Identification

Appendix to check_configuration, BL.3.05
A. Sasaki

Figure 1. <fault_vector> for tests on Memory Controllers, wirings, and Control Assignment.

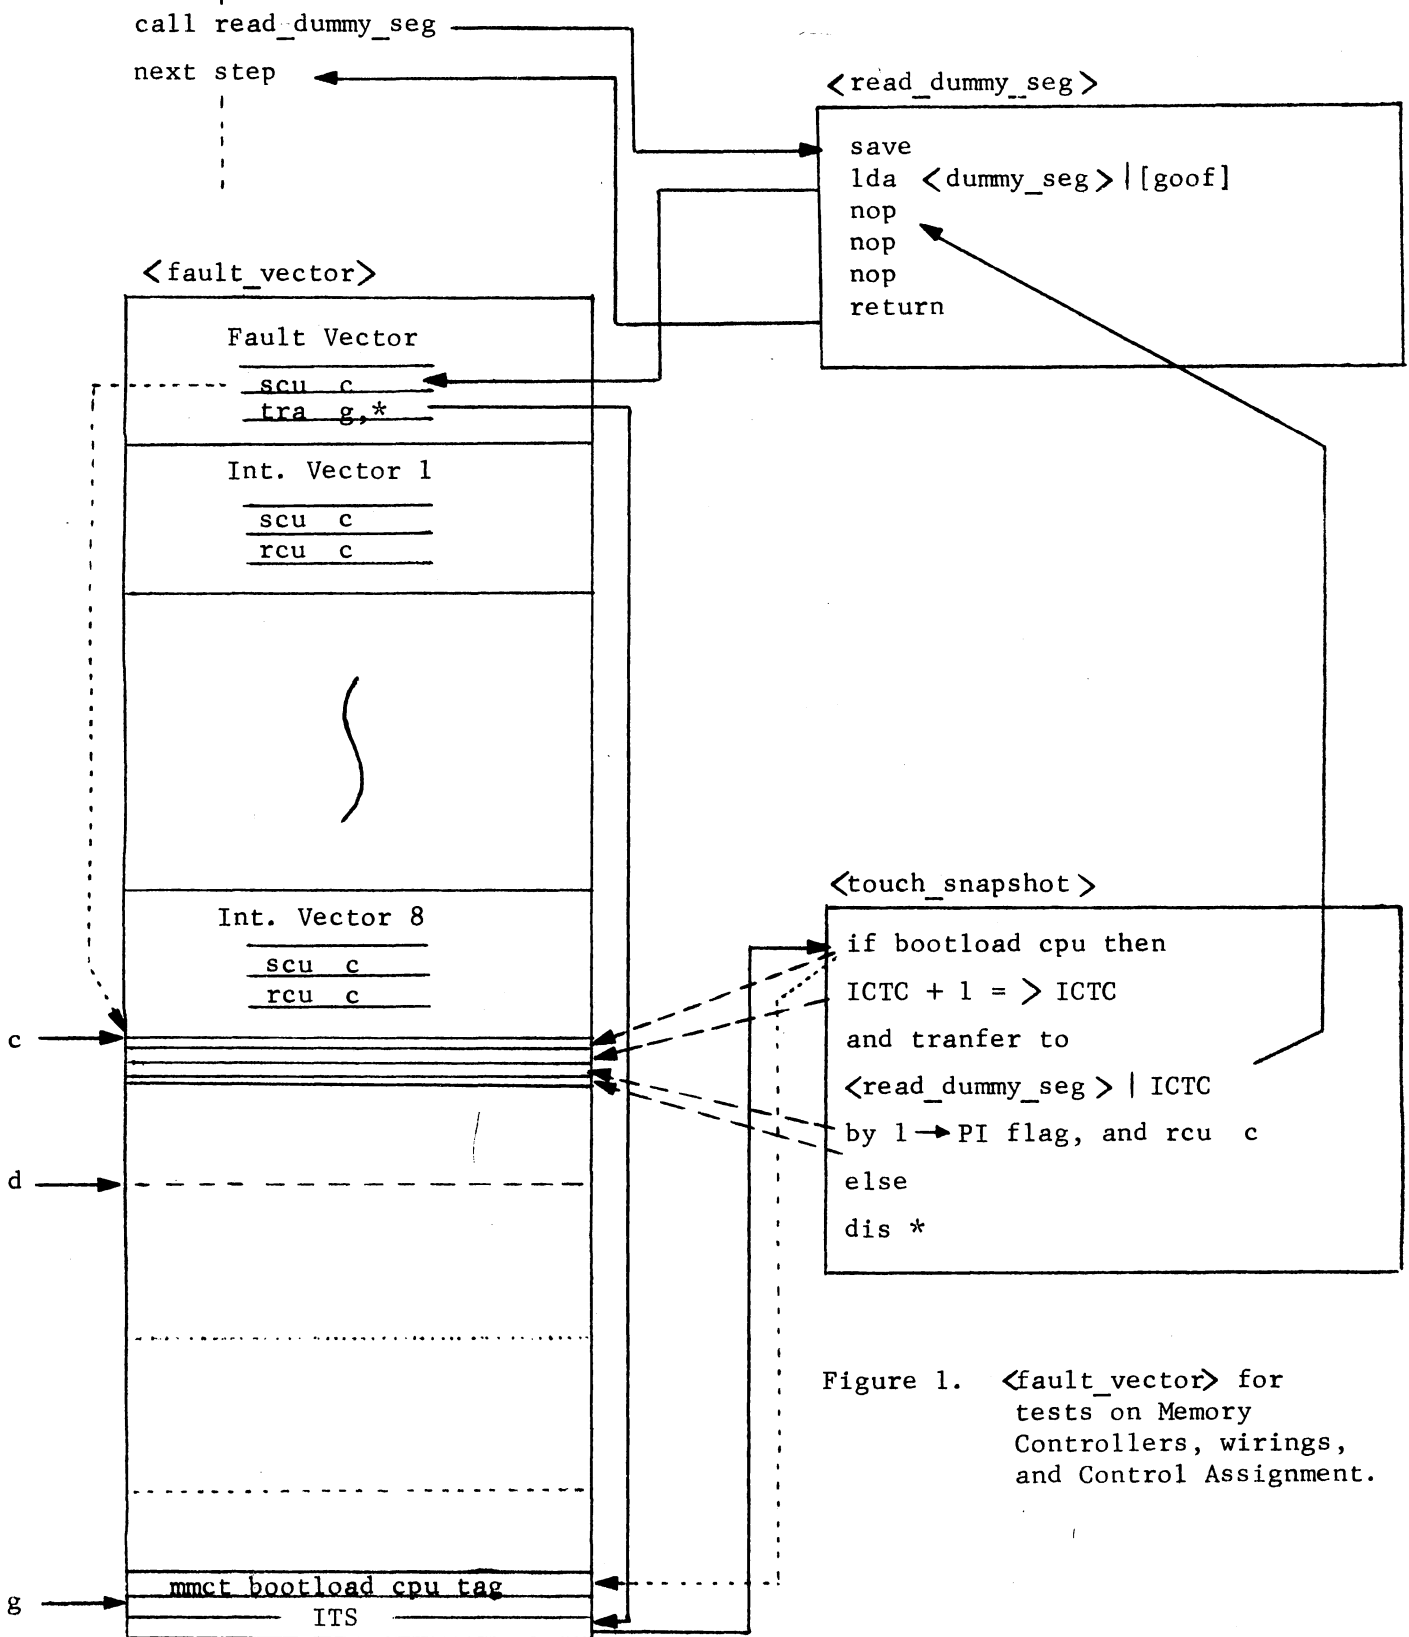
Figure 1 in BL.3.05 was a wrong copy.

Figure 1 in this section is the correct copy.
